STATE OF NEW YORK
OFFICE OF GENERAL SERVICES
DESIGN AND CONSTRUCTION GROUP
THE GOVERNOR NELSON A. ROCKEFELLER
EMPIRE STATE PLAZA
ALBANY, NY 12242

ADDENDUM NO. 5 TO PROJECT NO. 44578

CONSTRUCTION WORK - PLA
MAJOR BUILDING RENOVATIONS FOR THE
MANHATTAN FORENSIC
RELOCATION
MANHATTAN PSYCHIATRIC CENTER
600 EAST 125th STREET
WARDS ISLAND, NY 10035

August 27, 2015

1 BASEMENT FLOOR PLAN, PART "D"

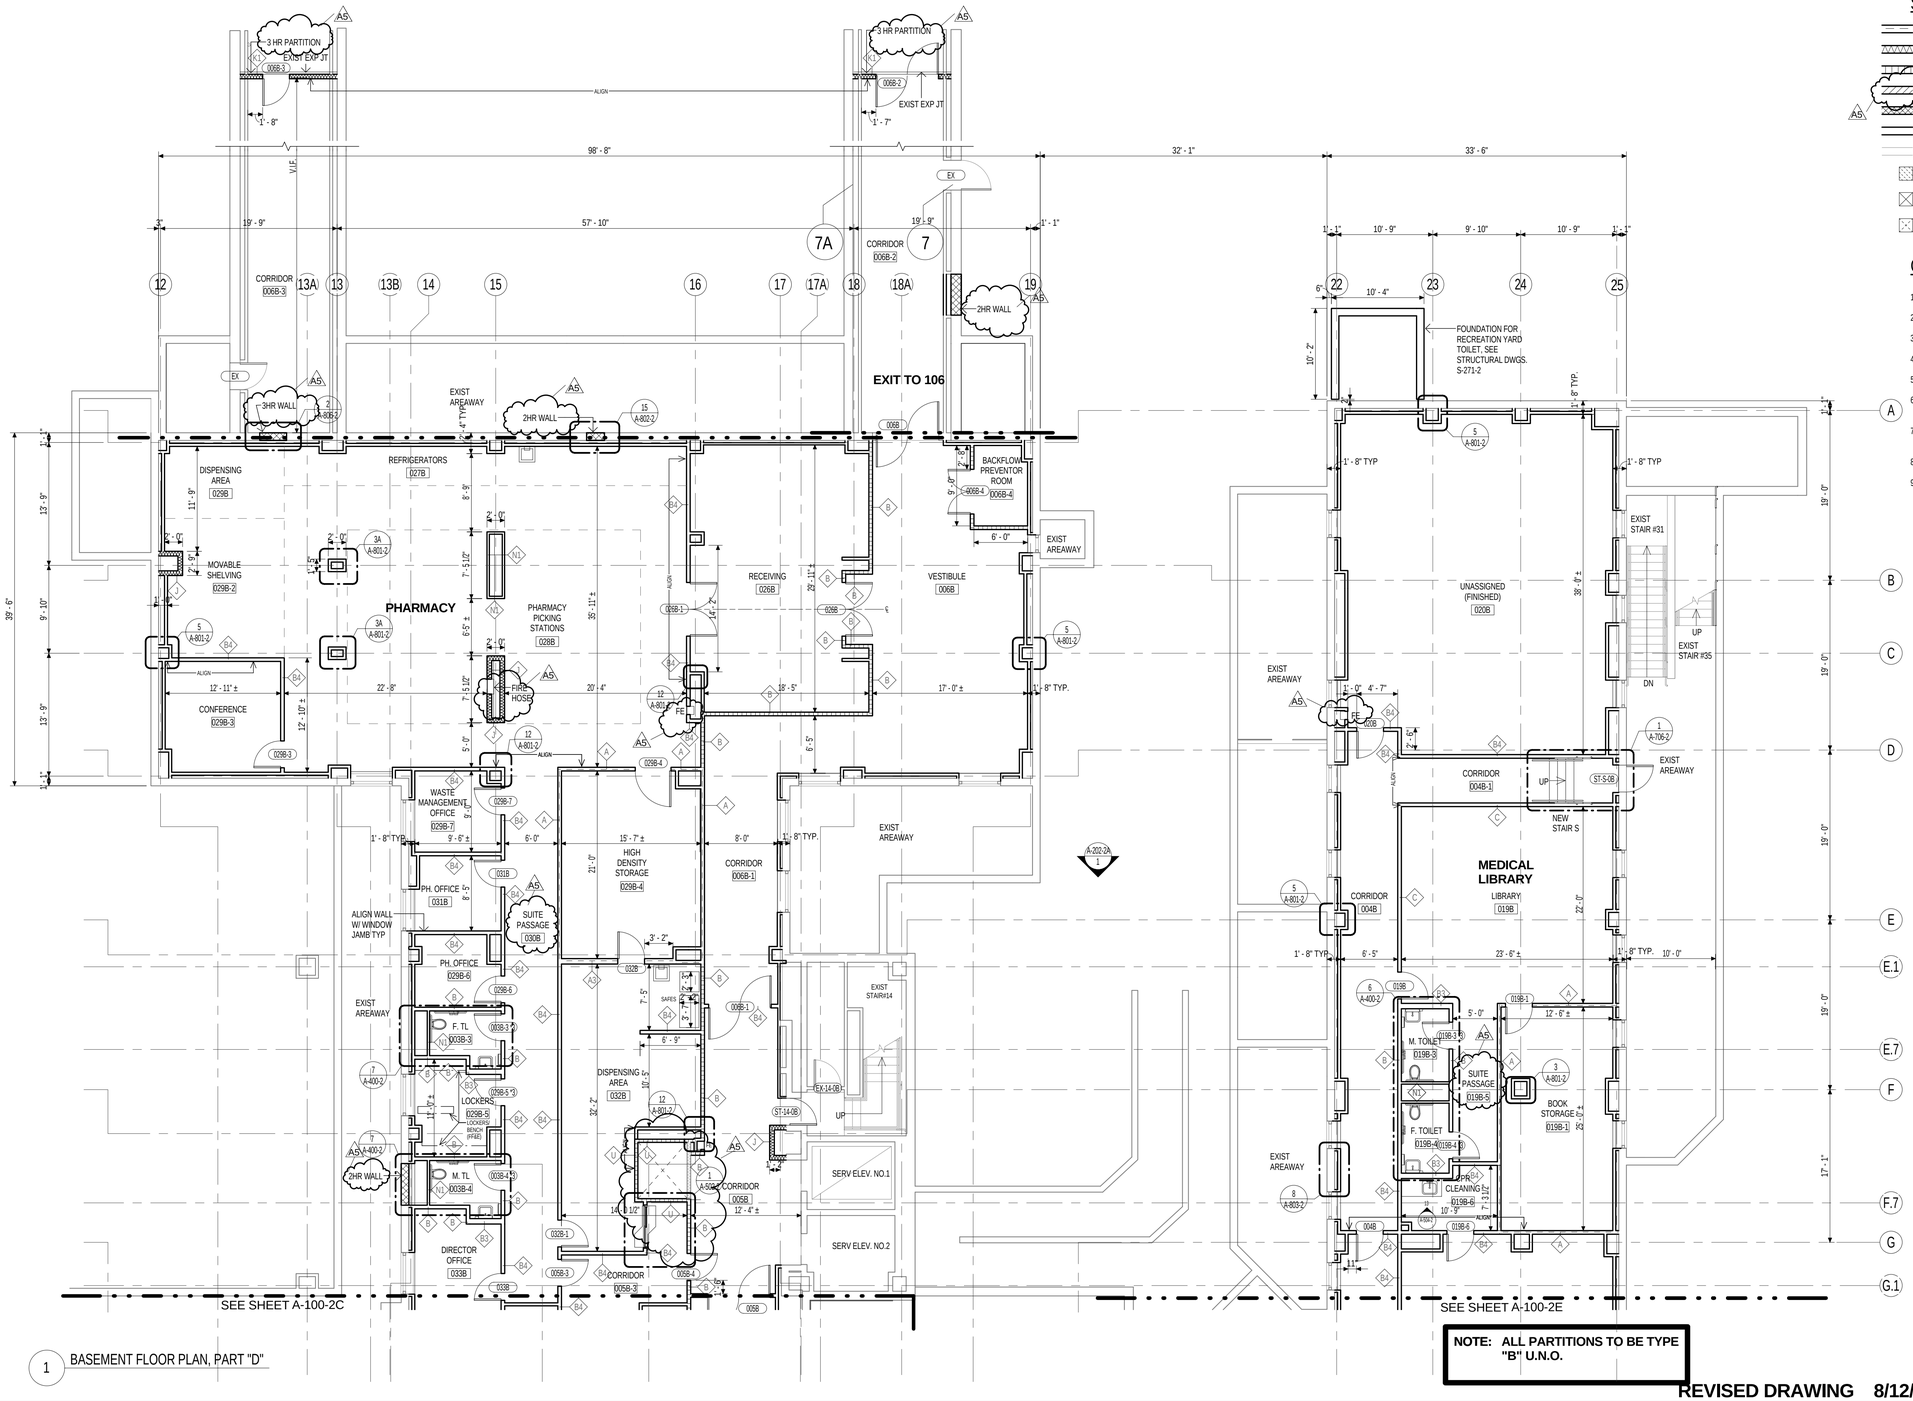
16. Drawing No. A-100-2D, BASEMENT FLOOR PLAN PART "D":
    a. Add Fire Extinguisher Cabinet at Col, Lines C&16 & D&22.
    b. Add one Fire Hose Cabinet at P and 24.

1 FIRST FLOOR PLAN, PART "A"

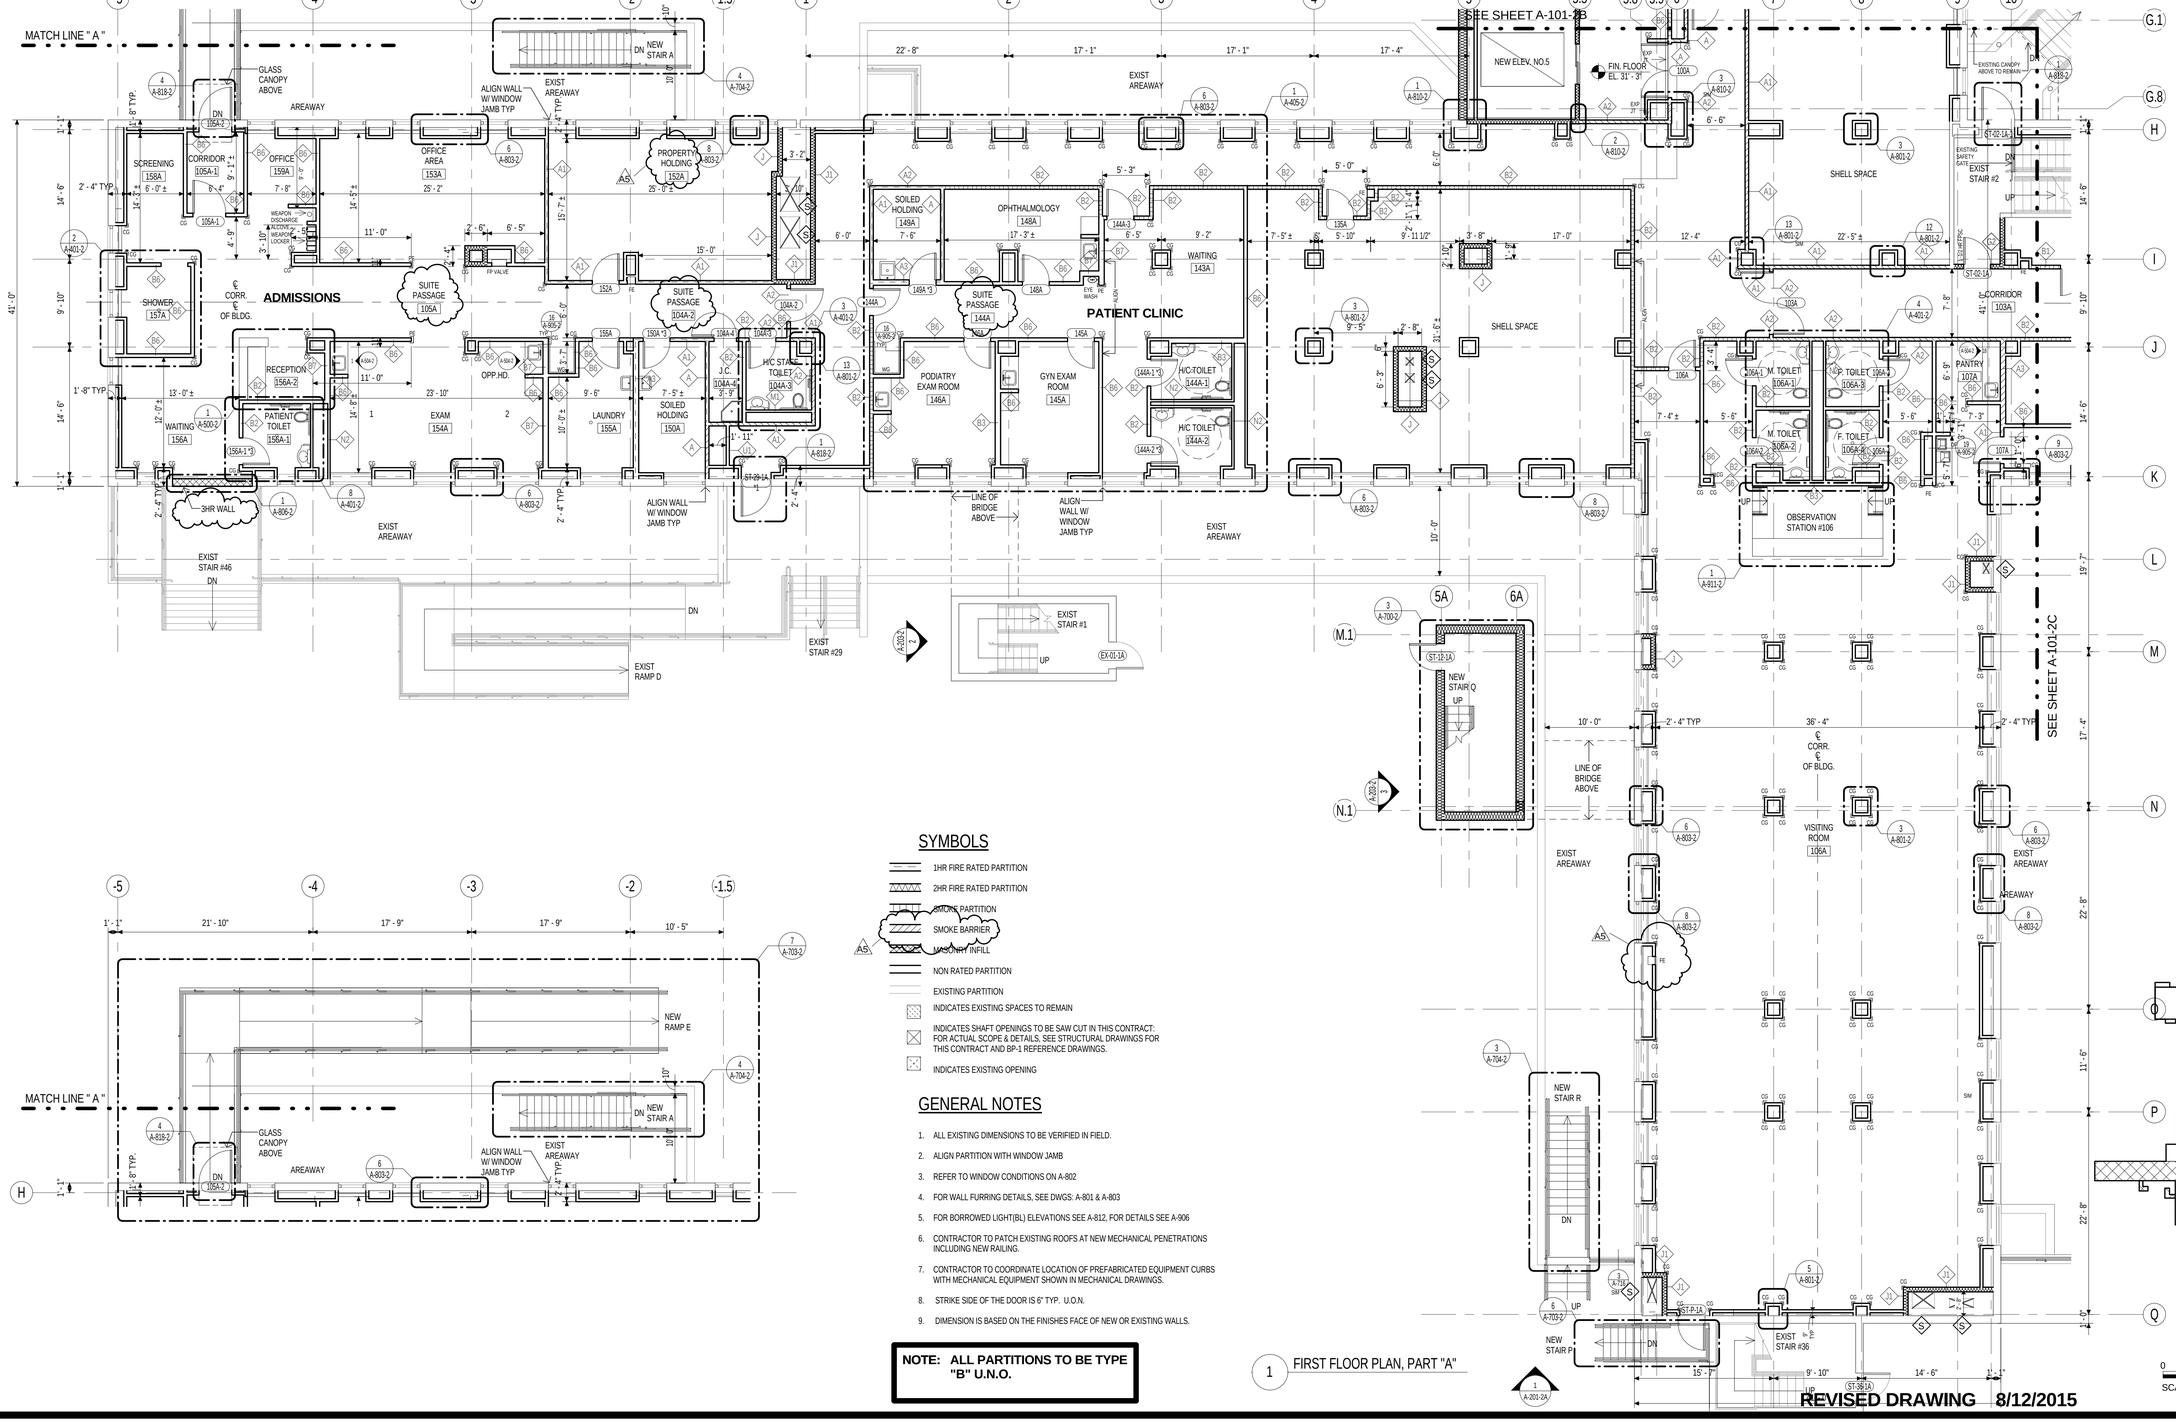
18. Drawing No. A- 101-2A, FIRST FLOOR PLAN PART "A":
    a. Add Fire Extinguisher Cabinet at Col, Line O and 5.9.
    b. Change the name of Room 152A from "Property Storage" to read "Property Holding"**.**

1 THIRD FLOOR PLAN, PART C

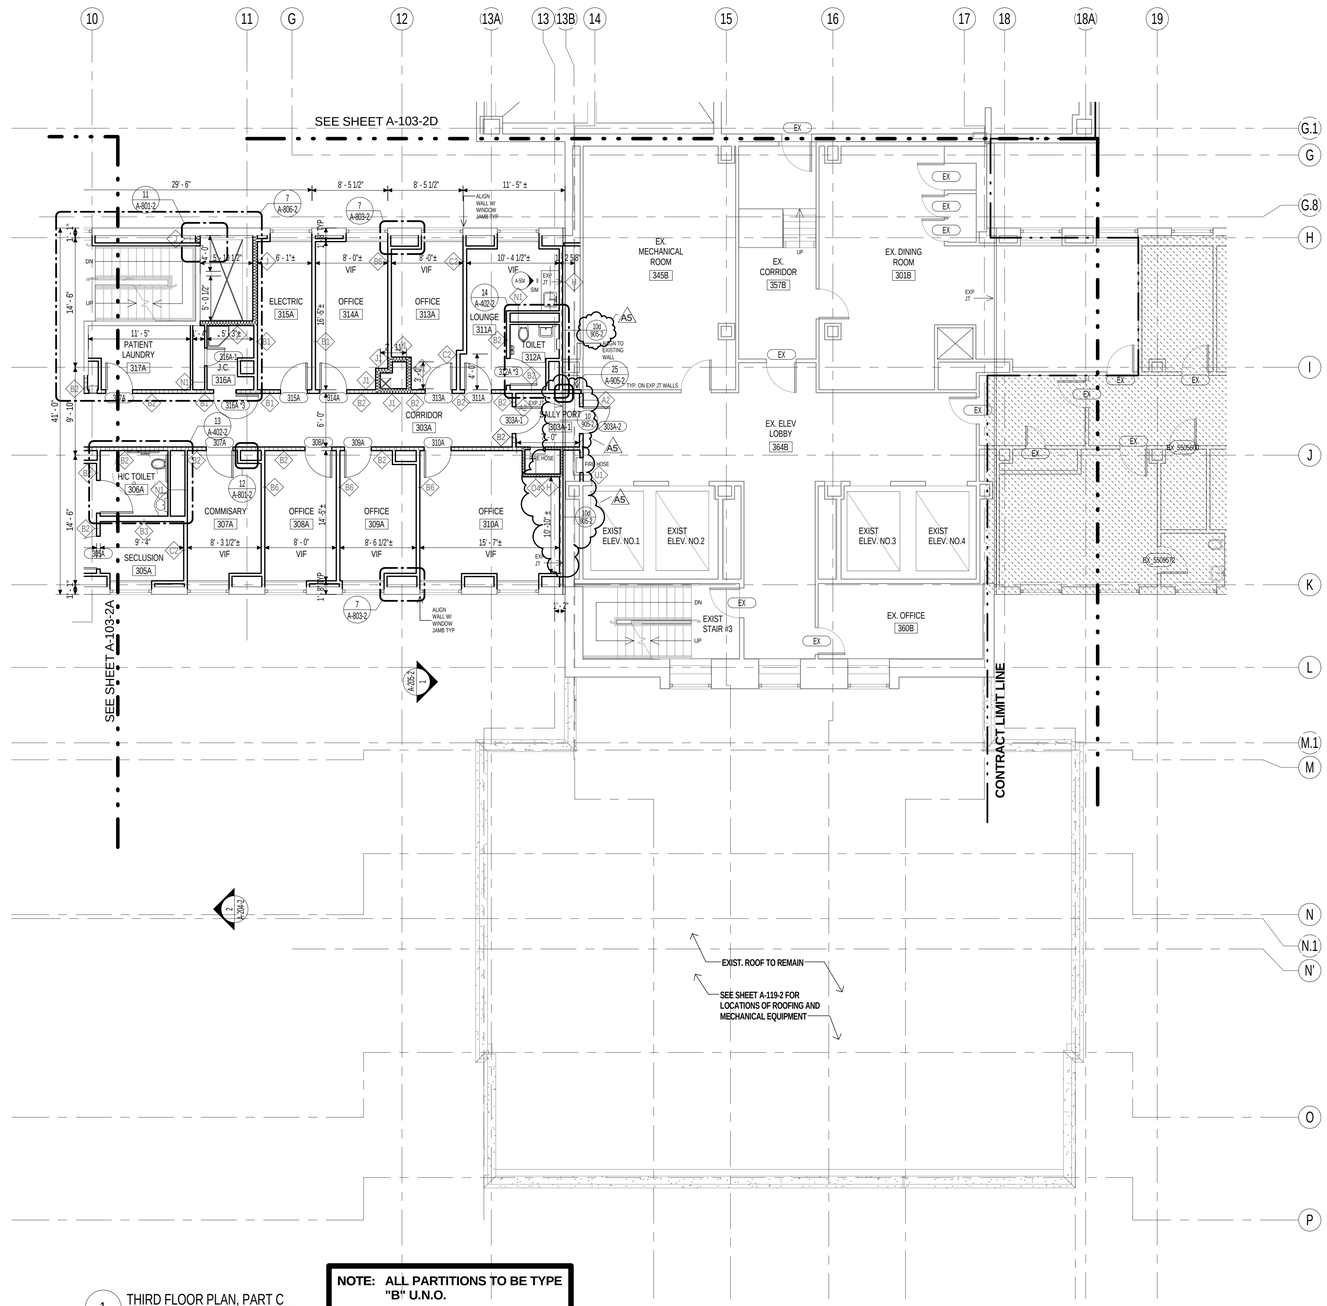
20. Drawing No. A- 103-2C, THIRD FLOOR PLAN PART"C": Revise "Wall Type A2" at Rooms 311A, 312A and 310A to one hr shaft wall design "Type H "as revised on Drawing No. A-900-
